Gold Standard Design Certification Renewal Report

“Afforestation Project in Tongliao, Inner Mongolia” (GS 3031)

Report No: CCIPL 2246/GS/RCP-VER/AFPT/20240408

Report Date: 24-March-2025

PDD-CL04-Enhancement of biodiversity

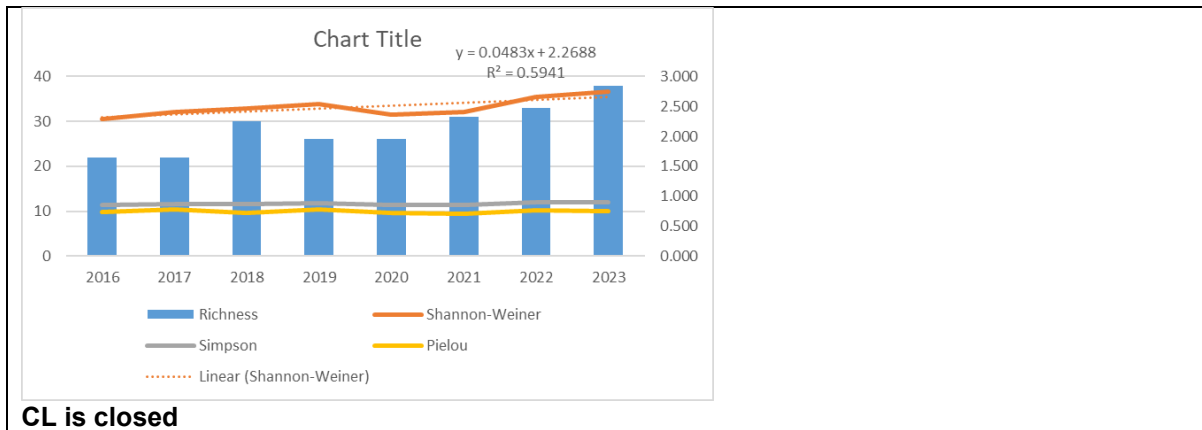
CL	04	Section no.	4.1.12 of GS Principles & Requirements v1.2	Date: 09/06/2024
Description of CL				
In line with Section 4.1.12 of GS Principles & Requirements v1.2,				
<i>“Changes in the project location or the extension of the project boundaries call for a re-assessment of the SDG Impacts and Safeguarding Principles, as does a significant change of scale of the project, even if located on the same site.”</i>				
PD shall provide the GS SDG Impact Tool as per SDG Impact tools – Gold Standard for the Global Goals .				
Project Developer Response				Date: 24/06/2024
At present, the EXCEL version of SDG Impact Tool can still be used, and the digital version is still undergoing training and will not become mandatory. PD has provided the latest GS SDG Impact Tool and modified corresponding statement of SDG Global goals in revised PDD and MR. According to Section 4.1.16 in Principles & Requirements, Option 1 was used to evaluate the SDG impact in first monitoring period (11/04/2014 to 31/12/2020) and the SDG13, SDG15, and SDG 16 were identified. From 13 March 2022, the SDG Impact Tools are a mandatory part of the project development cycle, and then Option 2 was used in second period time (01/01/2021 to 01/11/2023) to demonstrate SDG impacts of the project and the SDG13, SDG15, and SDG 8 were identified according to latest SDG Impact Tools. The monitoring indicators has been changed from the SDG 16 to SDG 8 “Total number of jobs” The GS SDG Impact Tool of the project has been provided as evidence.

The supporting monitoring data of biodiversity including the number of the species has been provided as evidence.
